Office Action Summary

Application No.
09/531,769

DETAILED ACTION

THIS ACTION IS RESPONSIVE TO THE AMENDMENT FILED 20 AUGUST 2001.

Not Approved - Do not enter.
- New Matter - circled in Red

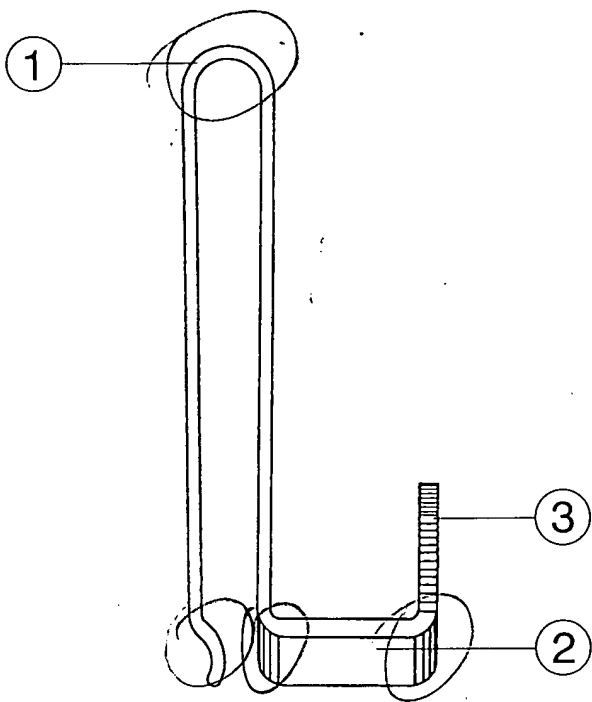
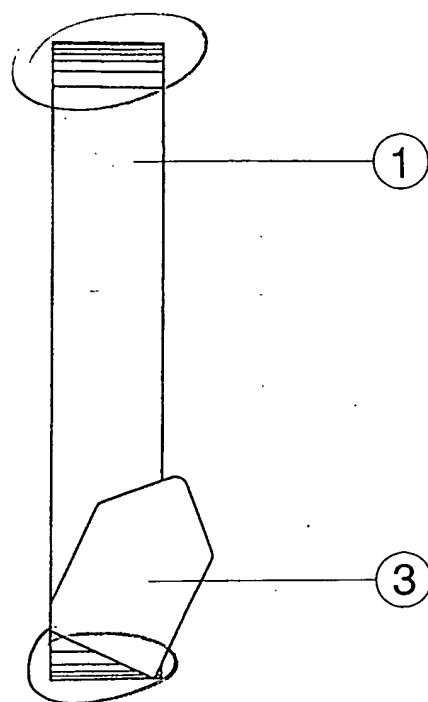
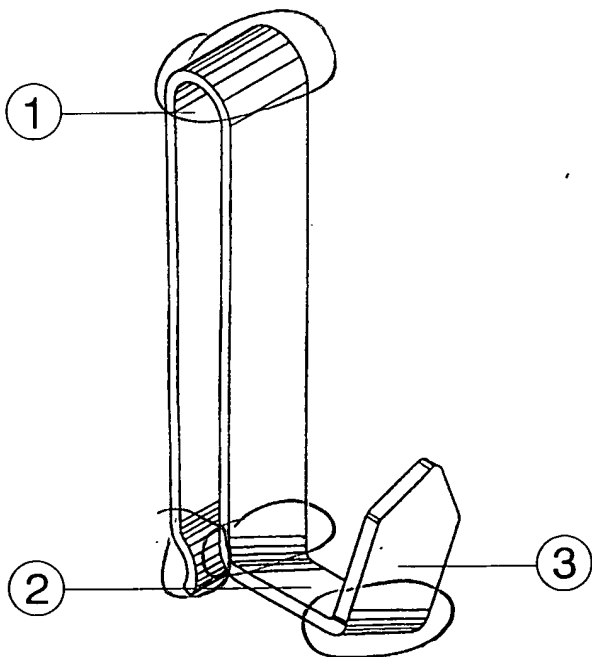
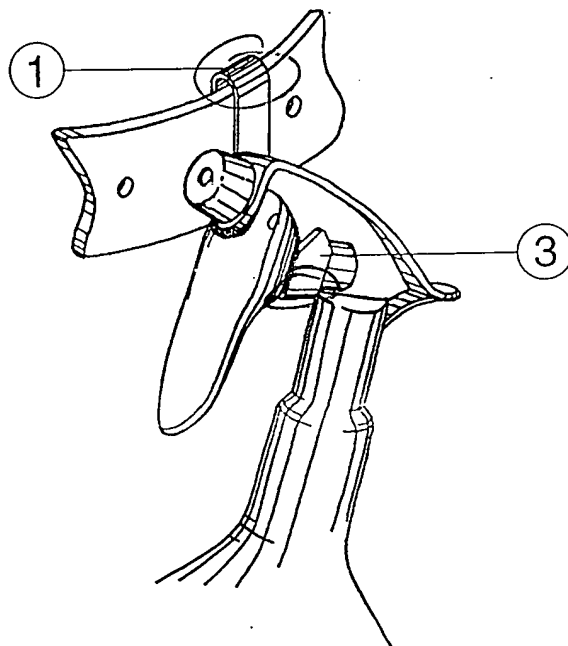
4. The proposed substitute sheets of drawings, filed on 8/20/2001 have been disapproved because they introduce new matter into the drawings. 37 CFR 1.121(a)(6) states that no amendment may introduce new matter into the disclosure of an application. The original disclosure does not support the showing of the curved/radiused features circled in red in the attached marked-up copy of the proposed drawing sheet (See Appendix). The original disclosure and written specification did not support the belt hook having the curved-radiused (i.e., rounded) portions at the proximal ends of the planar members comprising the hook. The originally filed drawing sheets support a disclosure of the belt hook device having planar members, where each of the body back, body front and rest are rectangular shaped planar members, and the rest guard

being a planar member having a tapered distal end portion, as shown in Fig. 4 of one of the two originally filed drawing sheets. Consequently, the proposed substitute drawing sheet has not been approved for entry.
